Attached please find NRC staff's request for additional information (RAI) concerning the review of Licensing Topical Report TR-0920-71621-P, Revision 0, "Building Design and Analysis Methodology for Safety-Related Structures," (Agencywide Documents Access and Management System (ADAMS) Accession No. ML20353A404).

## **Request for Additional Information 0002 (eRAI No. 9833)**

Application Section: TR-0920-71621-P, Revision 0

**Plan View**

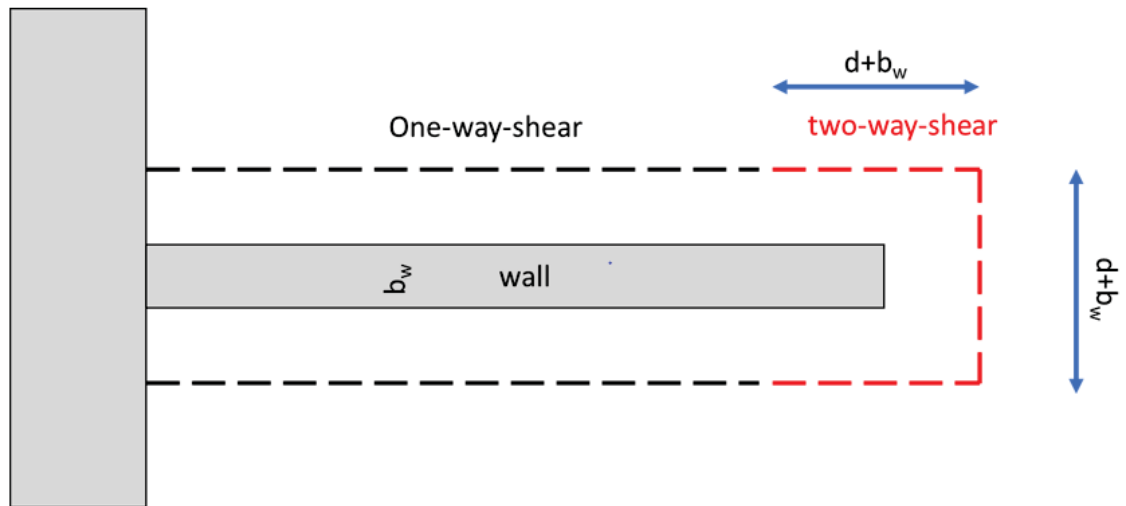
1. In Figure 8-9 of the TR, the applicant depicted the out-of-plane shear (shown in red) section cut "d" distance (from extreme compression fiber to centroid of longitudinal tension reinforcement) away from the wall. It is not clear to the staff why the applicant chose a distance of "d" for the out-of-plane shear (shown in red) section cut.

2. In Figure 8-10, "Section cut for two-way shear in basemat subject to wall overturning," of the TR, the applicant depicted the square section cut, in red, with a distance of " $d + b_w$ ," at each side at the end of continuous wall. In Section 8.5.1, "Section Cuts for Out-of-Plane Forces," the applicant also stated, *"if the out-of-plane shear demand calculated at these section cuts exceeds the basemat capacity corresponding to one-way or beam shear, then the failure mode would change to two-way or punching shear. In this situation, the shear capacity associated with this failure mode is instead considered and the associated demands are calculated at the section cut shown in red in Figure 8-10."*

However, it is not clear to the staff the source for the change of the failure mode of section cuts from one-way shear to two-way shear (punching shear), when the out-of-plane shear demand at these section cuts exceeds the basemat capacity corresponding to one-way shear. As shown below, it would be more correct to consider, both one-way shear and two-way shear, to get more accurate shear distribution around the shear perimeter of a slender blade-column in a foundation.

- The staff requests the applicant to describe the basis for choosing the distance "d" for the out-of-plane shear (shown in red) section cut.
- The staff requests the applicant to describe how the failure mode of cutouts change from one-way shear to two-way shear could independently be evaluated in a slender blade-column in the foundation if the out-of-plane shear demand corresponding to one-way section cuts exceeds the basemat capacity.
